Access Compliance Report

Public Rights-of-Way

(Pedestrian Signals)

Intersection ID: N/A	Main Street:	Cross Street: N/A	Location: N/A
ADA ID: BDAEA9AED8AC	Signal Type: One Push Button-APS	Overall Compliance: No	Severity Score: BTN 1: N/A BTN 2: N/A No BTN: N/A
Codes/Mitigation Info/Possible Solution		Field Measurements/Component Compliance

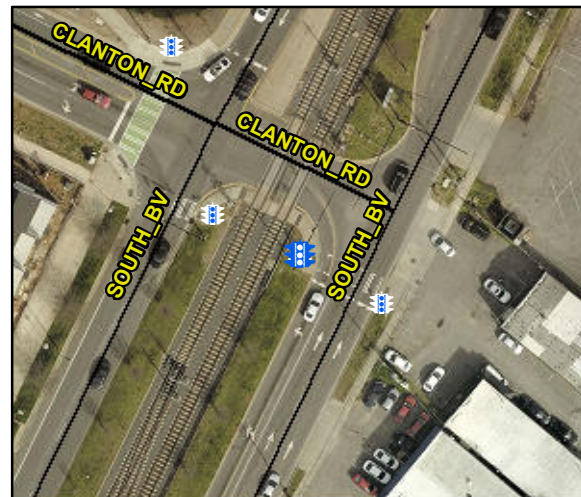
Yes	B 1 Clear Xing Direction?	ClearlyMarked	N/A	B 2 Clear Xing Direction?	N/A
	B 1 Crossing Direction	To SE		B 2 Crossing Direction	N/A
Yes	B 1 DistanceTo XWalk (in)	0.0	N/A	B 2 DistanceTo XWalk (in)	N/A
No	B 1 DistanceTo Curb (in)	89.0	N/A	B 2 DistanceTo Curb (in)	N/A
Yes	B 1 Diameter (in)	2.0	N/A	B 2 Diameter (in)	N/A

Possible Solutions: Replace Signal Push Button With APS Button on New Post. Remove & Relocate Sign.

Total Cost: \$ 650.00
